PLANNING, ZONING, & BUILDING DEPARTMENT  
PZ&B Staff Combination Memorandum: Architectural Commission and Town Council

SUBJECT: ZON-24-025 (ARC-24-015) 153 AUSTRALIAN AVE (COMBO)

MEETING: APRIL 24, 2024 ARCOM  
MAY 15, 2024 TOWN COUNCIL

CURRENTLY PROPOSED SOUTH ELEVATION

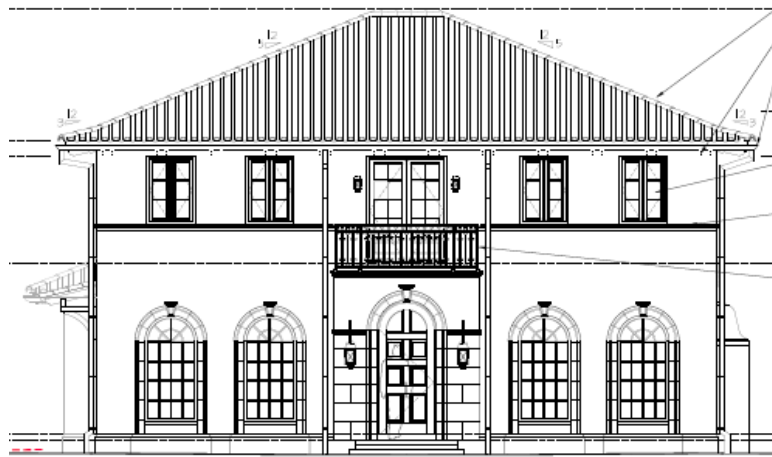
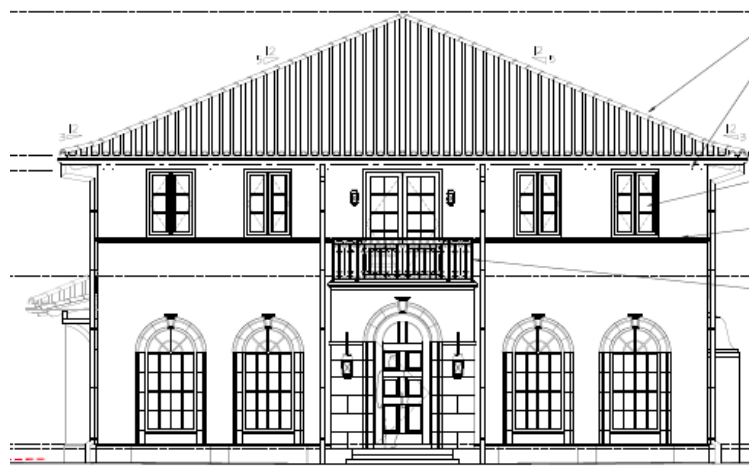
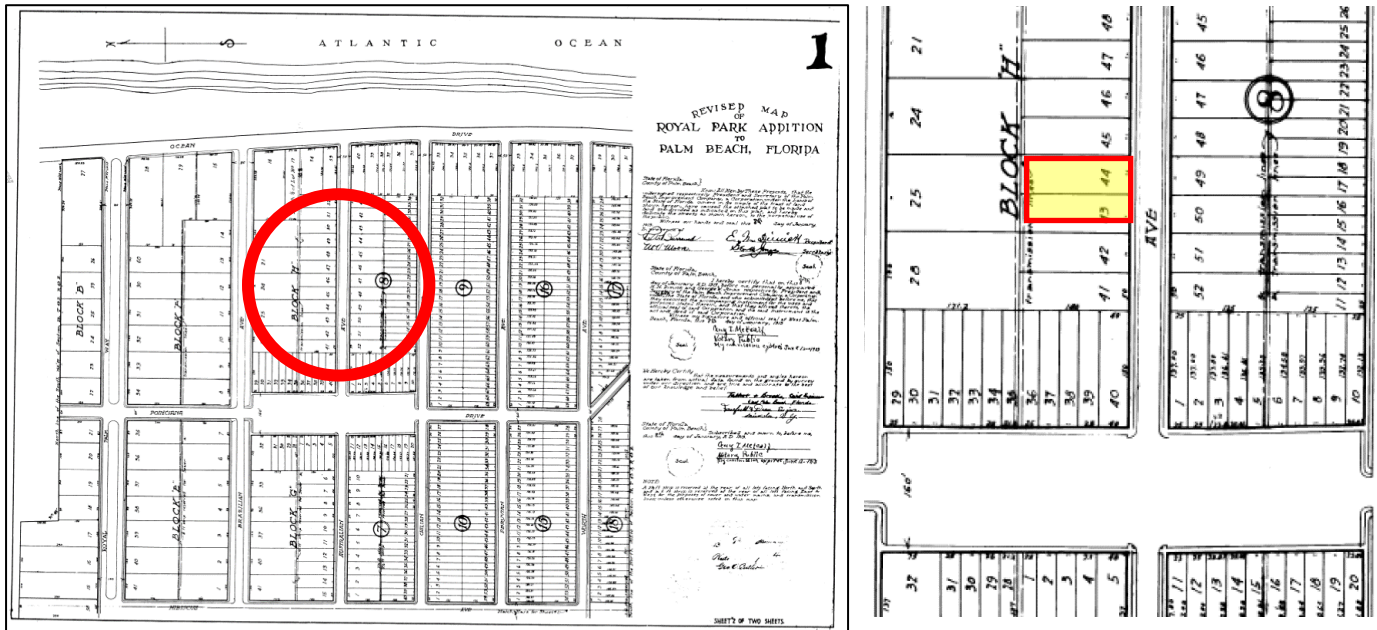
The applicant has resubmitted plans in response to comments of the commission. Changes include relocation of the belt course to the second floor sill, and modification of the entire roof, including elimination of previously proposed dormer windows. An alternate roof design is also included in the presentation.
